Office Action Summary

10/541,573

HATORI, SHIGEYUKI

DETAILED ACTION

Note for reference character A-C, Y and Z, refer to the following:

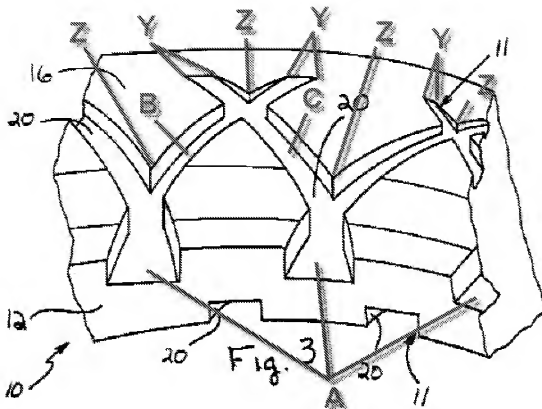
1. Claim 1 is rejected under 35 U.S.C. 102(b) as being anticipated by Dickey et al. (US Patent No. 6,189,896).

Regarding claim 1, the Dickey et al. reference, as best understood, discloses a seal ring (10) wherein

a plurality of circumferentially extending concaves (20) being provided along an inner circumferential part of the contact side face (Fig. 3) and separated from each other along the circumference of the side face by columnar surfaces (e.g. Z),

each end of each of said plurality of circumferentially extending concaves converges with a surface of the side face to form a converging point (Y), adjacent converging points being separated from each other by said columnar surface (Fig. 3),

each of said columnar surfaces extending radially outwardly from a line extending between adjacent converging points to an outer circumferential edge of the side face (Fig. 3),

each of the concaves being formed by a first deepest inclined portion (e.g. portion at A) provided in the inner circumferential part of the side face of the seal ring, the first deepest inclined portion being provided to reduce a thickness of the seal ring toward an inner circumference of the seal ring (Fig. 3), and

a second inclined portion (e.g. B and C) being provided on an inner circumferential side of each columnar surface and extending radially inwardly from said line extending between adjacent converging points to the inner circumferential edge of the side face of the seal ring to reduce the thickness of the seal ring toward the inner circumference of the seal ring (Fig. 2), the converging portion converging toward the innermost points of the column portion (i.e. starting from Y and moving down, the concave portions converge to Z).
